## **Alternatives for High-Level Waste Salt Processing at the Savannah River Site**

Committee on Cesium Processing Alternatives for High-Level Waste at the Savannah River Site, Board on Radioactive Waste Management, Board on Chemical Sciences and Technology

At the request of the U.S. Department of Energy (DOE), the National Research Council formed a committee to provide an independent technical review of alternatives selected by representatives at the Savannah River Site (SRS), South Carolina, for processing the high-level radioactive waste (HLW) salt solutions stored at the site. This review, which is summarized in this report, addresses the following four charges in the committee's statement of task:

FIGURE 2.1 Schematic outline of the screening procedure used to identify a recommended alternative for cesium removal. SOURCE: Westinghouse Savannah River Company.

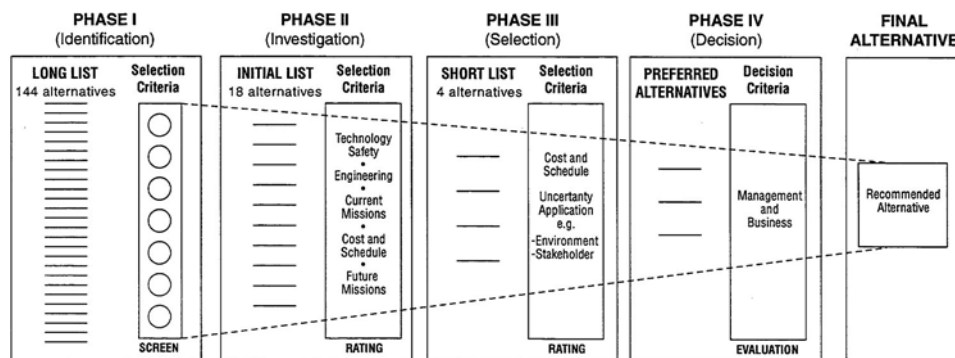
The 'Long List' included some process alternatives that were obviously not pertinent (e.g., geologic disposal). Further, some of the categories into which the 144 processes were divided were not sought during the literature search (e.g., vitrification); on the other hand, some alternatives (e.g., electrochemical) were included in the 'Long List' of 144 processes even though their presence in the global literature search was trivial. Finally, and most importantly, some of the processes identified in the literature search as extensively described and even applied on a plant scale were not present in

- c) SRS and its contractors appeared to provide inadequate attention in the screening procedure to the role of the cesium separations process selection on the entire HLW system, particularly the steps preceding cesium separations. Evaluation of the explicit interfaces of unit operations (e.g., strontium and plutonium removal) on the risks associated with candidate processes for cesium removal appeared to be incomplete. The committee con

- 3) In response to the committee task, “Was an appropriately comprehensive set of cesium partitioning alternatives identified and are there other alternatives that should be explored?”, the committee recommends that no further effort be expended at this time in alternative identification.

- 4) In response to the committee task, “Was the process used to screen the alternatives technically sound and did its application result in the selection of appropriate preferred alternatives?”, as noted previously the committee concludes that the screening procedure was cumbersome, complex, and lacked transparency to document the technical soundness of an evaluation and selection of appropriate preferred alternatives based primarily on the best judgment of experts using many qualitative factors. The committee recommends that future such evaluations, depending on expert judgment, be documented in a clear, easily understandable and traceable manner to allow for viable reviews. Although the screening procedure did result in the selection in the ‘Short List’ of what the committee believes are at least four appropriate preferred alternatives, further reduction of the alternatives will have to await completion of adequate R&D on each.
